Project	IEEE 802.16 Broadband Wireless Access Working Group < http://ieee802.org/16 >	
Title	Structure and notation enhancements to IEEE P802.16h/D3	
Date Submitted	2007-11-15	
Source(s)	Paul Piggin NextWave Broadband Inc. 12670 High Bluff Drive San Diego CA 92130 USA	Voice: 1 858 480 3100 Fax: 1 858 480 3105 ppiggin @ nextwave.com
Re:	Letter Ballot #29 of IEEE P802.16h/D3.	
Abstract	There are a number of structural and notional enhancements that should be applied to the IEEE P802.16h/D3 draft.	
Purpose	Ensuring the readability of the draft IEEE P802.16h/D3.	
Notice	<i>This document does not represent the agreed views of the IEEE 802.16 Working Group or any of its subgroups. It represents only the views of the participants listed in the "Source(s)" field above. It is offered as a basis for discussion. It is not binding on the contributor(s), who reserve(s) the right to add, amend or withdraw material contained herein.</i>

Structure and notation enhancements to IEEE P802.16h/D3

Paul Piggin
NextWave Broadband Inc.

Figure h x1x—The relationship between frame boundaries and the DMA algorithm

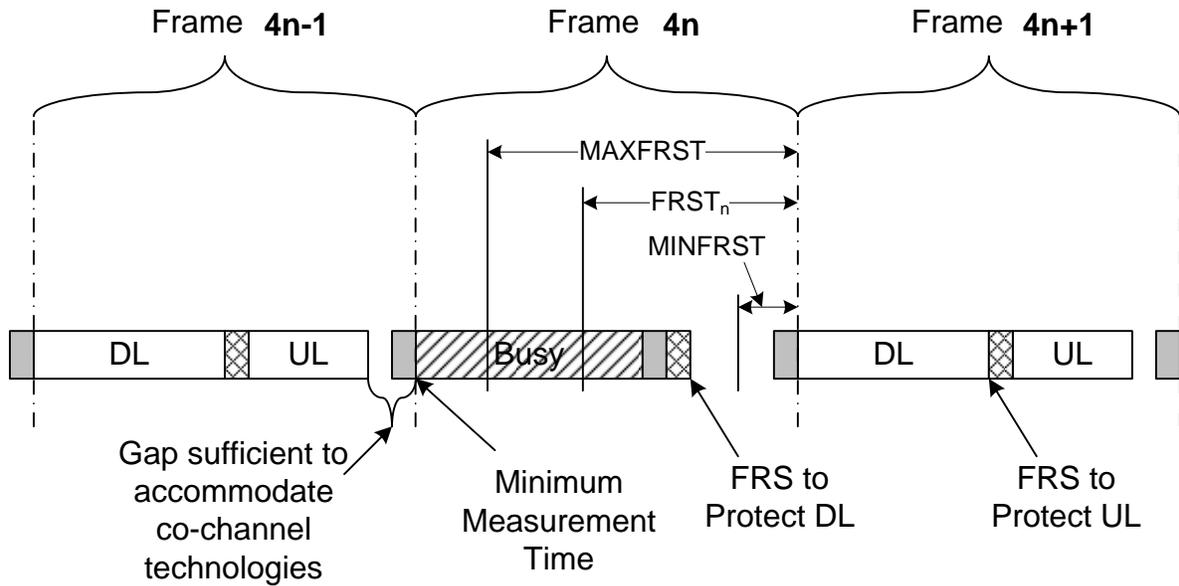
The relationship between frames boundaries and the DMA algorithm is shown in Figure h x1x; tThe DMA algorithm timing parameters are applied as shown in Figure h 19.

Figure h19—~~Reclaiming the Medium~~Timing parameters of the DMA algorithm

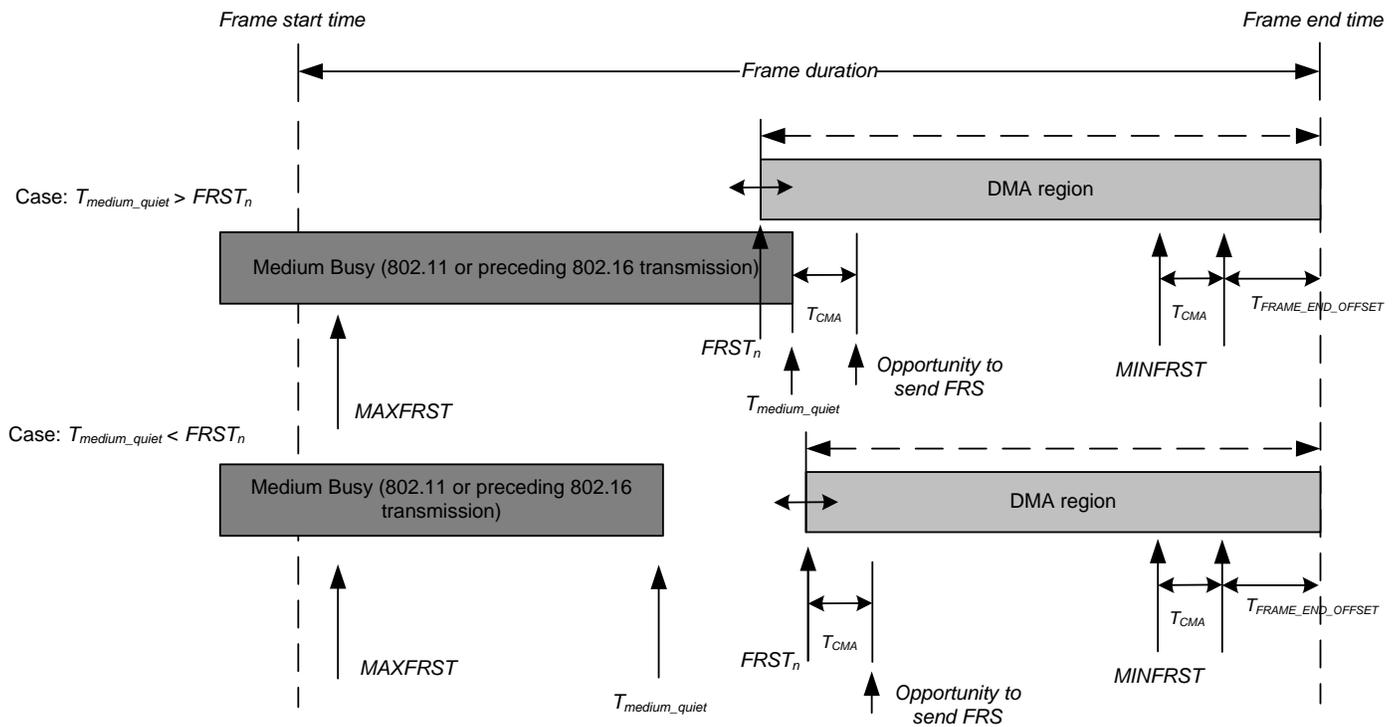
Replace Figure h19 in [1] ‘Reclaiming the Medium’ with the following. Also make the caption changes as shown.

$$MINFRST = T_{CMA} + T_{FRAME_END_OFFSET}$$

[Figure h21 \(a\) Downlink FRS](#)

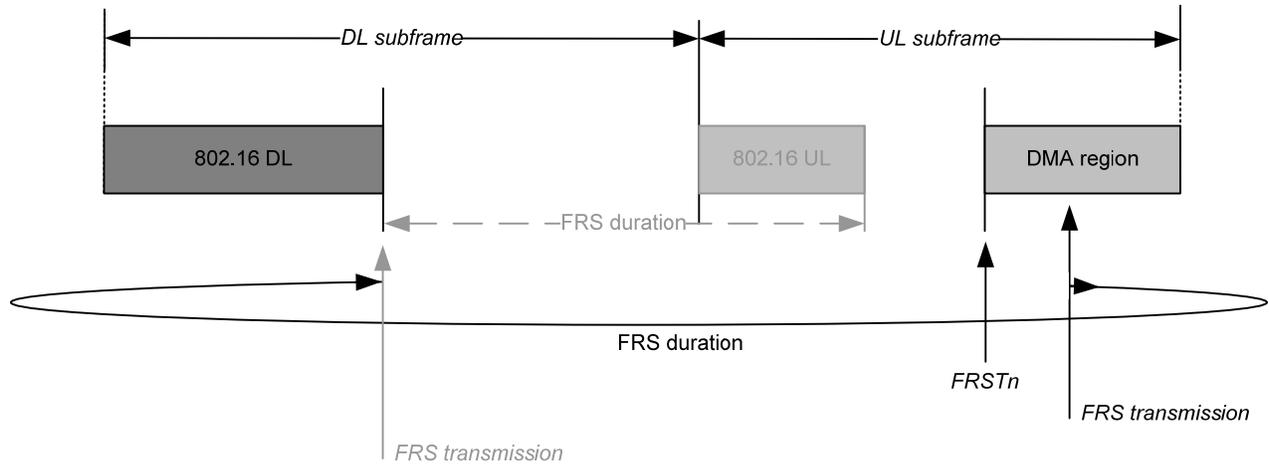
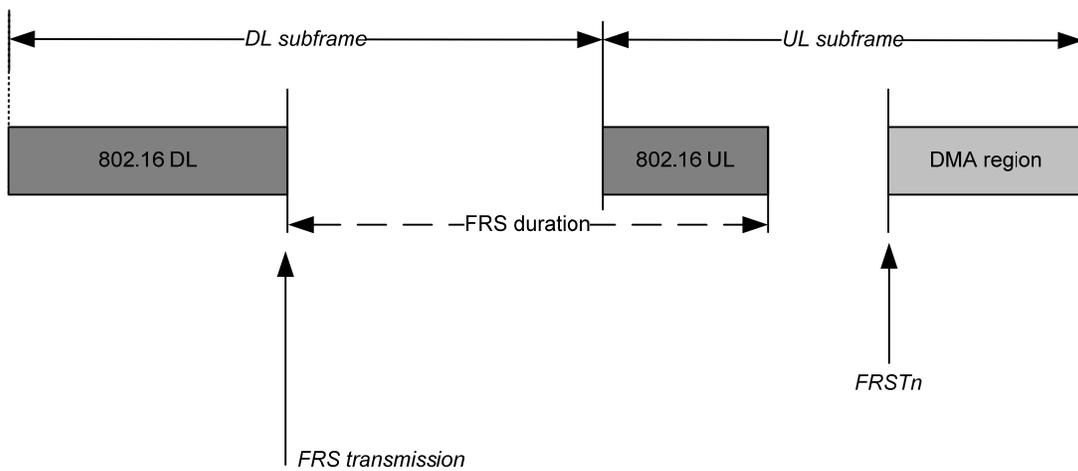
When using any carrier sense protocol, such as LBT, in a wireless environment the hidden node problem cannot be 100% avoided. It can only be mitigated. Additionally, in bands such as 3.65 GHz in the US, there is an aggravated hidden node problem due to the distinctly lower transmit power allowed for mobile devices compared to fixed, registered devices. The mobiles are more often geographically disadvantaged due to this transmit power disparity. Fixed, registered client devices can also be geographically disadvantaged (the classical hidden node problem), although not as often. To remedy this the BS transmits a Frame Reservation Signal (FRS) at the end of the DL subframe to reserve the subsequent UL subframe (or used portion, thereof) for the subscriber stations. [The BS also transmits an FRS in the DMA region at the time a decision is made to claim the medium.](#) The form of the FRS is band dependent and should be structured to be receivable by other technologies that may be co-channel. For instance, in bands where 802.11 would be a typical co-channel asynchronous system, the 802.11 CTS transmitted using the appropriate 802.11 burst structure would suffice. The reservation of the [DL and](#) UL subframe by the BTS precludes the need for the SS to also perform LBT. ~~The use of~~ [An example of using](#) the FRS to protect the [DL and](#) UL is shown in *Figure h 21*.

Replace figure h21 with the following.
